CITY OF FREDERICKSBURG HISTORIC REVIEW BOARD

TUESDAY, JULY 12, 2022

7. CERTIFICATE OF APPROPRIATENESS APPLICATIONS CONSENT AGENDA

- D. Application- #21-085 **209 E San Antonio**– *Bow Carpenter*- construction of new covered outdoor seating, new outdoor bar and restroom, window replacement (pg 45-66)
- E. Application- #22-064 **406 E Main**– *SKT Architects*- enlargement of parking lot (pg 67-74)

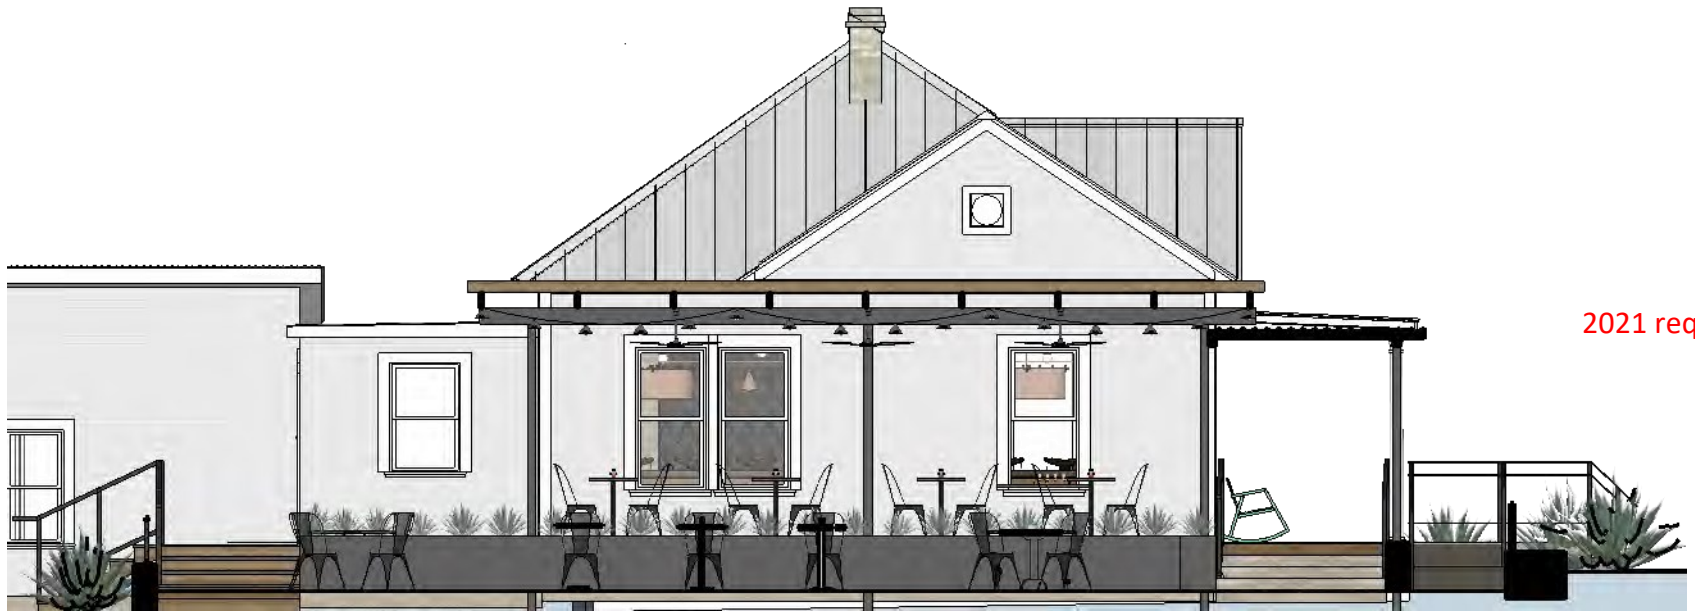
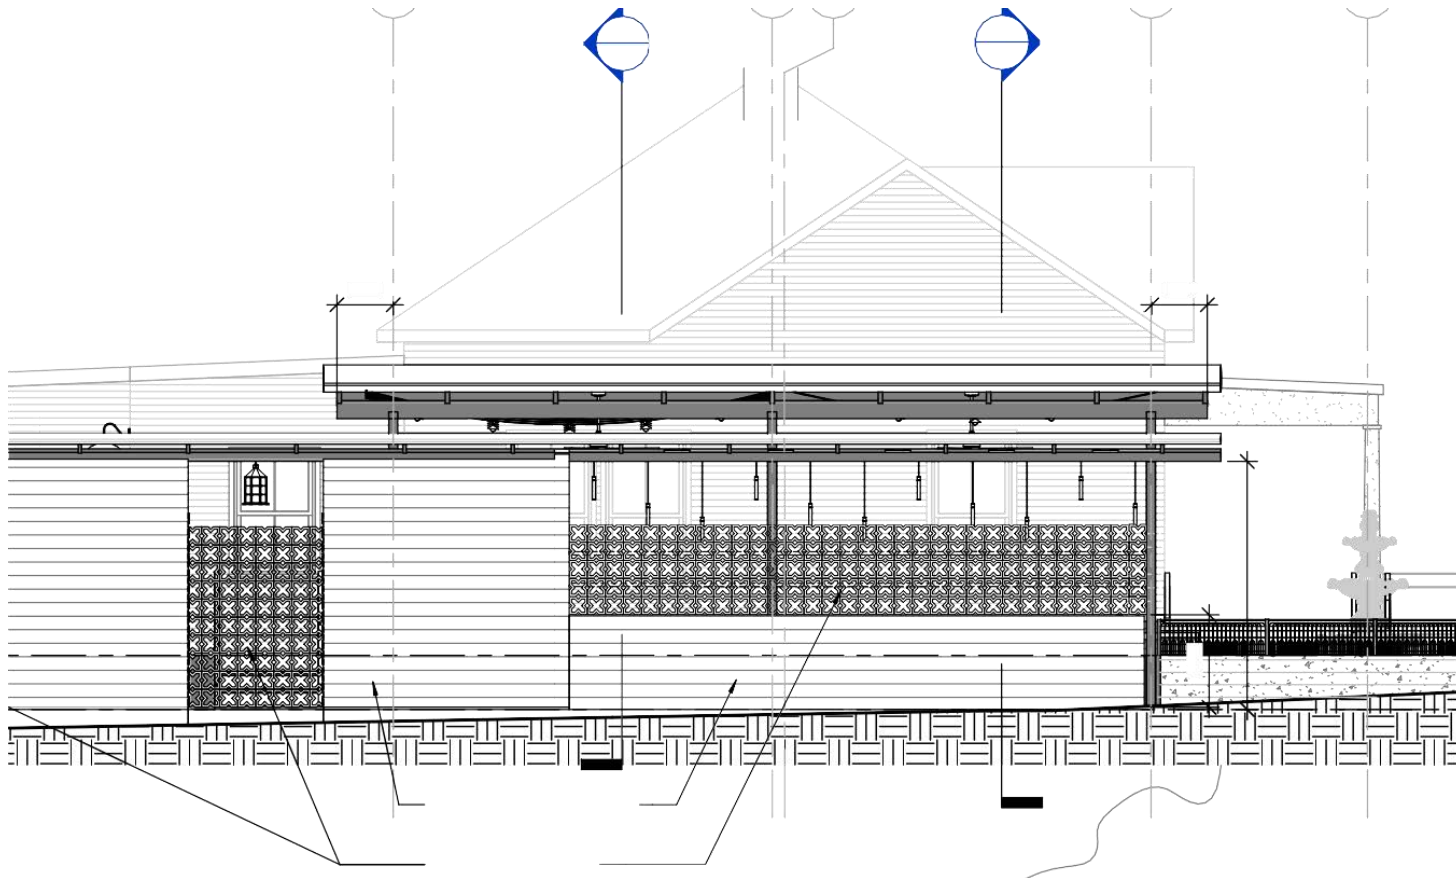
- **HRB Comment:** *“Staff recommends the new pergola/covered trellis is pulled back from the front façade. The height is compatible, and the openness of the structure is a benefit. More detail is needed on how the pergola will abut the side of the house.”*

- **HRB Comment:** *“site currently has garden loop that should be kept and re-used where fencing is necessary”*

- **HRB Comment:** *“The fountain/pond has been modified over the years, but a pond feature was present in the 1940’s. Other landscaping features include concrete perimeter edging found on the side (east) yard. Staff recommends the design incorporate as many original features as possible.”*

- **HRB Comment:** *For final approval more detail is needed on the proposed bar and restrooms along with lighting fixtures for the front porch and yard.*

Response: We have pulled the columns away from the existing structure by 5’-11.25” from the previous 2’0” distance which opened up the east façade of the existing structure. We removed the smaller trellised roof (the extension of the existing front porch) which also helped with the “openness” of the existing east façade of the structure. Refer to sheet A110.

Response: We have incorporated the “garden loop” into the site perimeter fencing, refer to sheet 1/A200

Response: A new fountain is being placed in the general location of the existing pond that pays homage to the existing pond while integrating with the new design and function of the outdoor space.

Response: See updated Elevations on sheets A200, A201, A300, A900. Actual Light fixtures to be selected by owner. Light fixtures shown to be LED and conform with dark skies requirements.
